Replies to Comments from Mr. Bruce Severance dated 15 April 2024

prepared by Mark Kirk for the DCISC · 22 May 2024

Part 2 Report, Figure 4. Comparison of consultant's ART estimates (curves) with those of PG&E (diamonds) for the timeframe 2003-2011 [Diablo LRA 2009] and 2011-today [WCAP-17315]. The NRC's required process for adjusting data is described in the Part 1 report, Section 2.4.2.2.

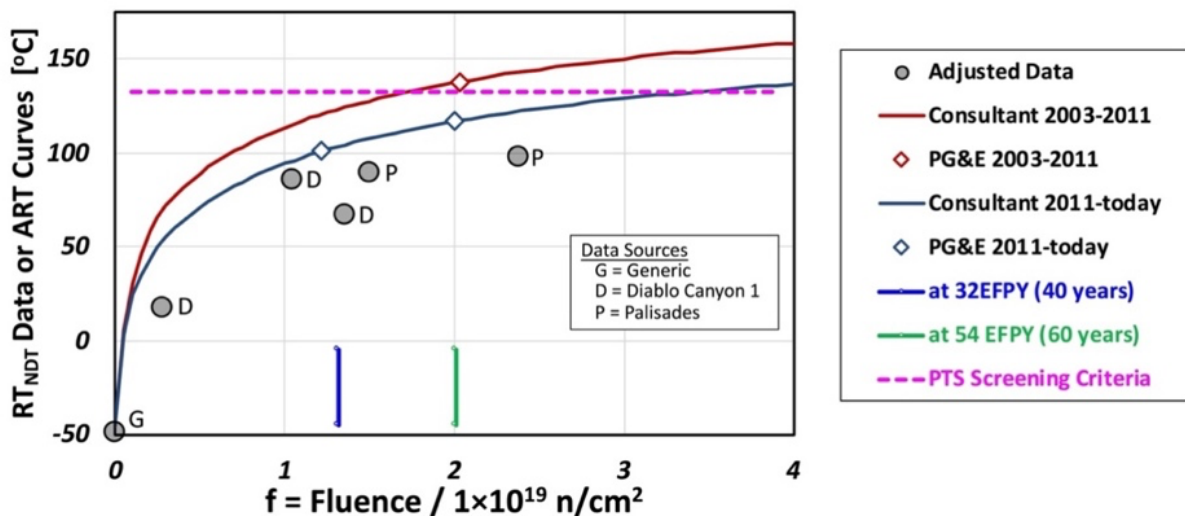
Comment “The pre-2004 test data and PG&E’s own 2006 calculations indicate this embrittlement will be reaching the Federal Code of Regulation “screening limits” [on pressurized thermal shock as expressed in 10 CFR 50.61]¹ by 2025 (also confirmed by NRC in 2006)”

Reply The statement that, based on data available before 2004, Diablo Canyon Unit 1 was forecast to exceed the PTS screening criteria in 2025 is incorrect. This information does not agree with that submitted by PG&E as part of its 2009 license renewal application [Diablo2009 LRA], which was based on the pre-2004 surveillance capsule data from Diablo Canyon Unit 1 cited in this comment. [Diablo2009 LRA] provided the following information.

Figure 4 of the Part 2 report, which is copied below for convenience, validated this RT_{PTS} estimate to within 1 °C. The dark red curve on Figure 4 shows this estimate of RT_{PTS} to be below the PTS screening criteria (270 ° F or 132.2 °C) at the 32 EFPY fluence but above the screening criteria at the 54 EFPY fluence. The information from Figure 4 was used to determine that, using only information available before 2009, the PTS screening criteria was then forecast to be exceeded at a fluence of $1.8 \times 10^{19} \text{ n/cm}^2$, which would occur at approximately 46 EFPY. However, in 2025 refueling outage Diablo Canyon Unit 1 is currently forecast to reach 35.2 EFPY. Thus, the statement

in the comment that, based on data available before 2004, Diablo Canyon Unit 1 was forecast to exceed the PTS screening criteria in 2025 is incorrect.

It should also be pointed out that the 2006 RT_{PTS} estimates cited by this comment are no longer current. Since 2011 additional information on the limiting weld (weld wire heat 27204) has been available in the form of two ΔT_{41J} measurements made by the Diablo Canyon's "sister plant" Palisades [WCAP-17315]. When incorporated into the PTS analysis, as required by the NRC, those data demonstrate that Diablo Canyon Unit 1 will not exceed the 10 CFR 50.61 screening criteria until long after 60 years of operation (see blue curve on the Part 2 report, Figure 4, which is copied below). The Part 2 report validated the [WCAP-17315] evaluation Diablo Canyon Unit 1 surveillance data as augmented by the sister plant data from Palisades (also see the figure).
